REMARKS

Claims 1-17 stand rejected under 35 USC §112, first paragraph, as failing to comply with the enablement requirement.

Claims 15-17 stand rejected under 35 USC §103(a) as being allegedly unpatentable over Gordin (US 6,676,277) alone or in view of <u>Bellek</u> (US 3,189,212).

FIG. 1 PRIOR ART

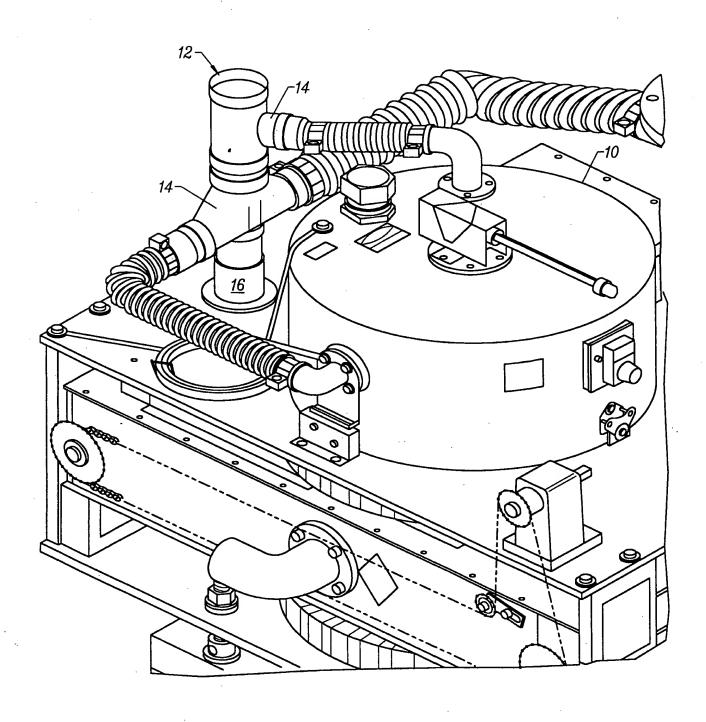
FIGS. 1 and 2 stand objected to on the grounds that the legend "Prior Art" is missing. FIGS. 1 and 2 have been amended to designate FIGS. 1 and 2 with the legend "Prior Art."
